OPTIONAL SERVICE BULLETIN

NO. OSB-42-046/2

Retrofit of the TAE 125-02-99 engine

TAE125-02-99 Preassembled Engine Retrofit Installation

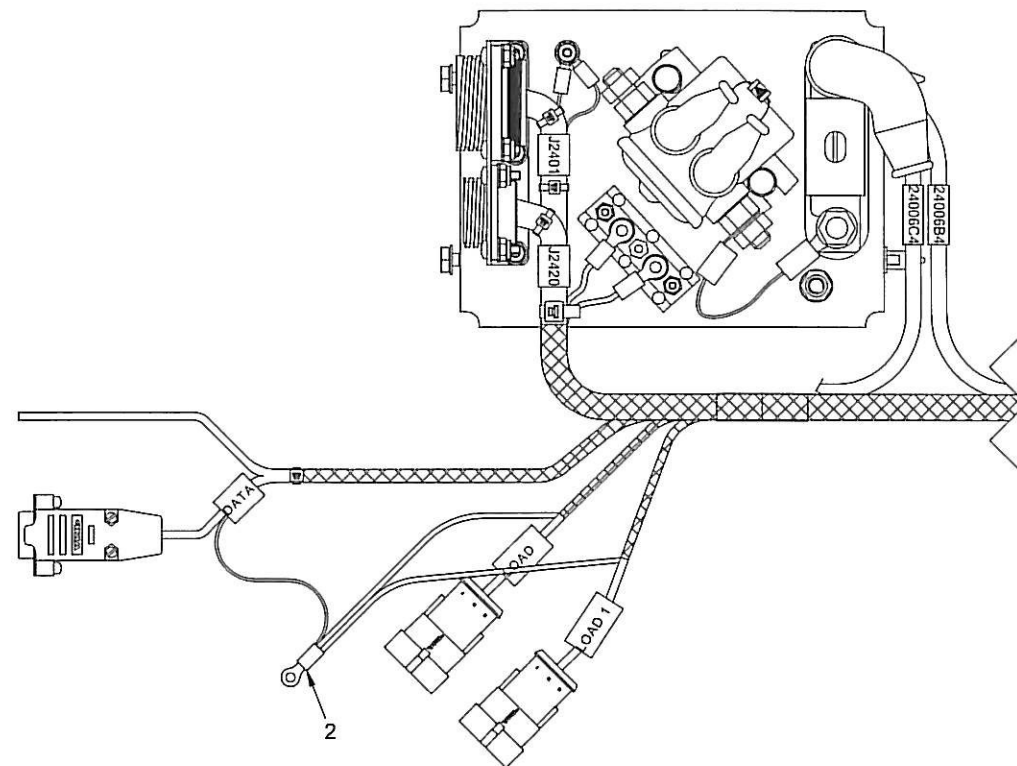
Step 4:
Install the 3 shield wires into one ring terminal, Position 2.

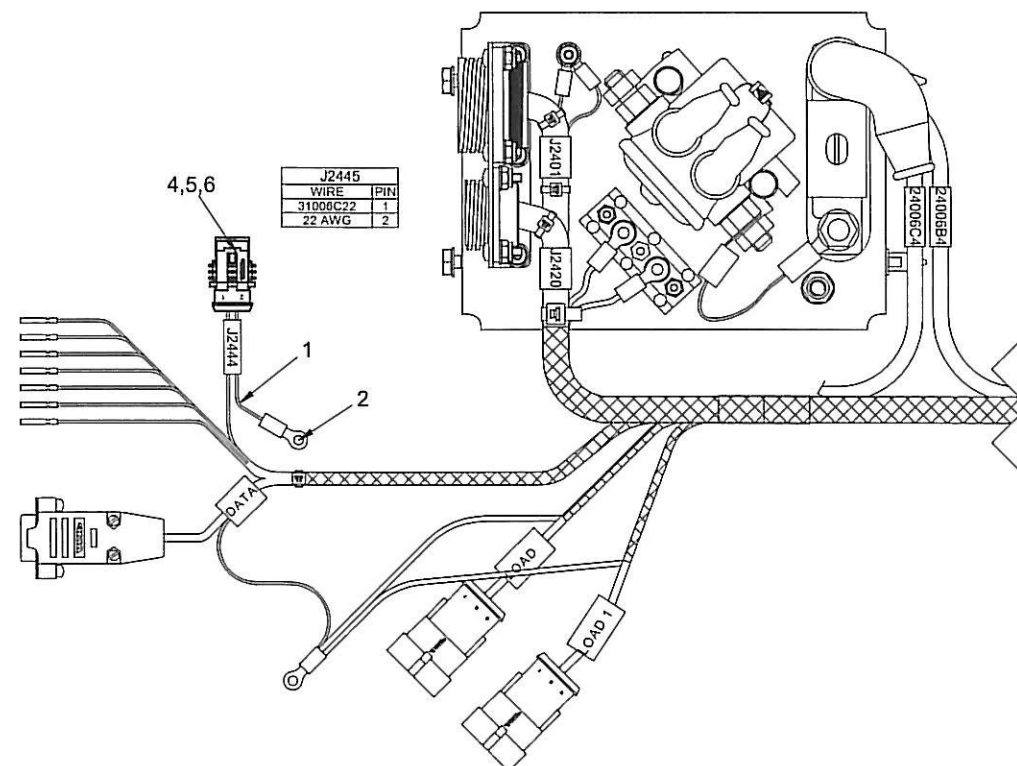
Step 6:
Install connector and label, Positions 4, 5, 6 onto wire 31006C22, Pin 1.
Install 150mm #22 AWG into Pin 2 and a ring terminal Pos. 2 on the other end.

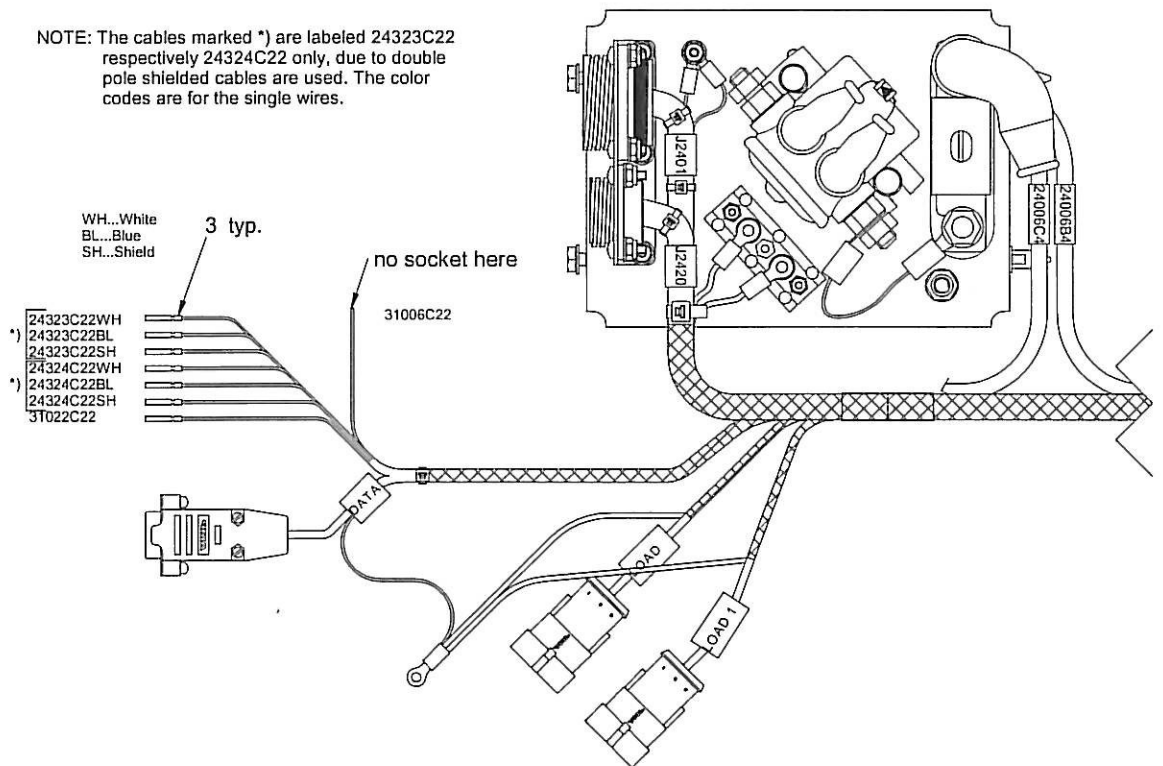
Step 5:
Crimp sockets, Position 3 onto the wires shown below.

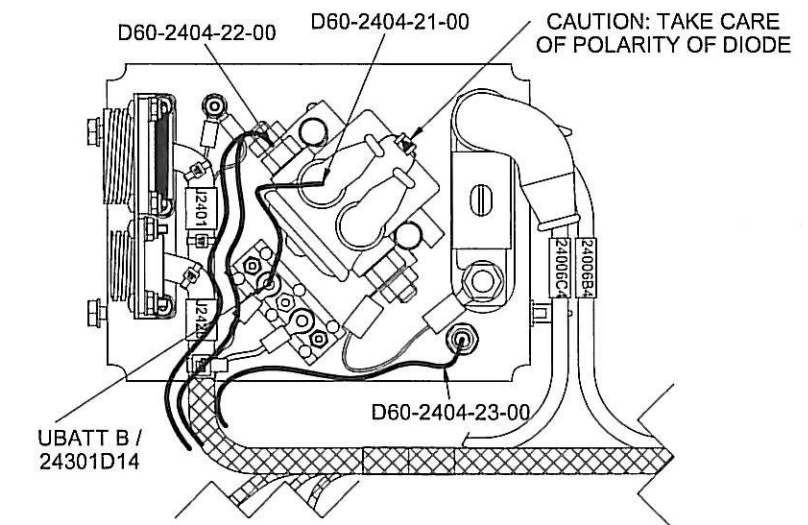
Step 7:
Install Wire, Glow Rel + (D60-2404-21-00-SB); Wire, Glow PWR (D60-2404-22-00-SB) and Wire, Glow GND (D60-2404-23-00-SB) as shown below.

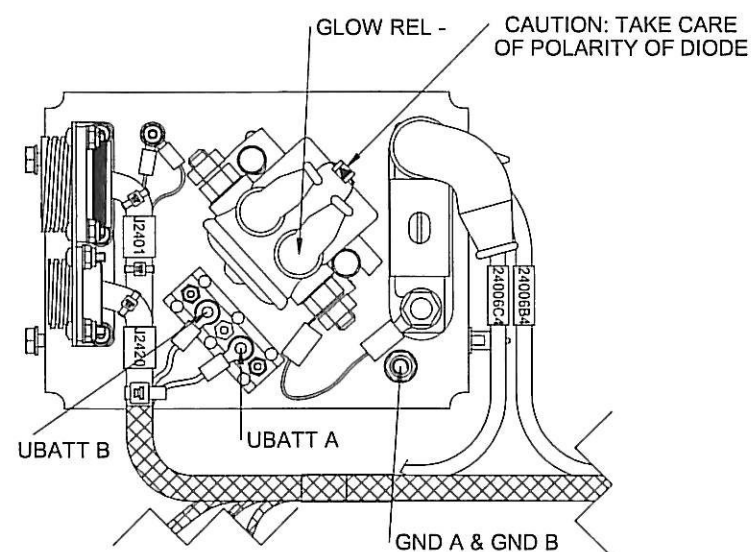
Step 7:
Connect Adapter Harness, Central Connector (D60-2404-20-00-SB) as shown below.

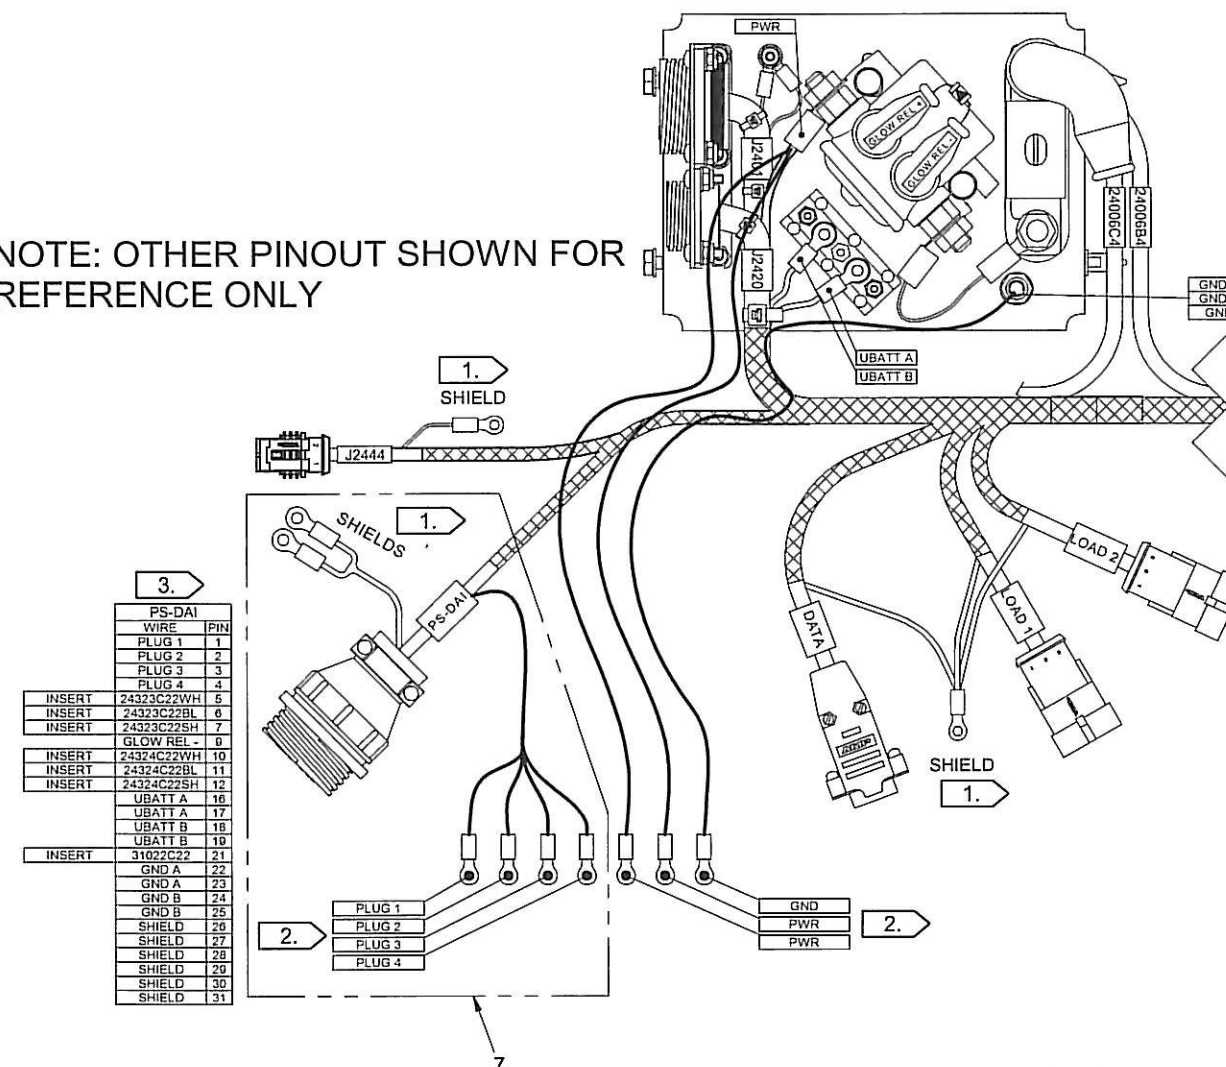
Step 8:
Insert the sockets, prepared in Step 5, into the new central connector (PS-DAI) as shown below.
